1970 Corvette: Service Bulletin: 1970 Corvette Folding Top Material Interference with Lid Pin Support

Source: Chevrolet Dealer Service Technical Bulletin

Bulletin No: 70-T-46

Date: Oct. 27, 1970

FIGURE 1

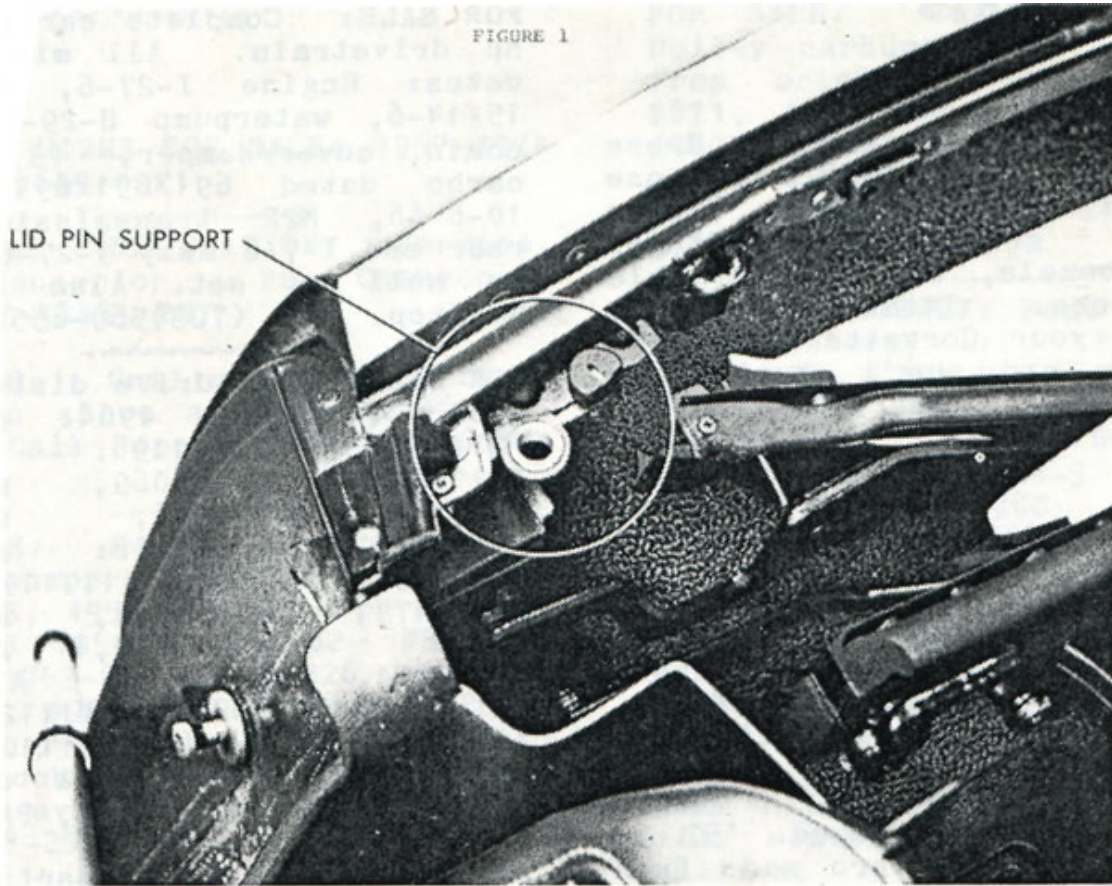
1970 Corvettes assembled prior to Serial Number S400748 may have interference between the folding top material and the top compartment lid pin support. This interference may result in damage to the folding top material.

1. Remove the lid pin support. (See Figure 1).
2. Grind 3/8" x 3/4" off the inboard edge of the support. (See Figure 2).
3. Reinstall the lid pin support and inspect to insure adequate clearance exists between the folding top material and the support.
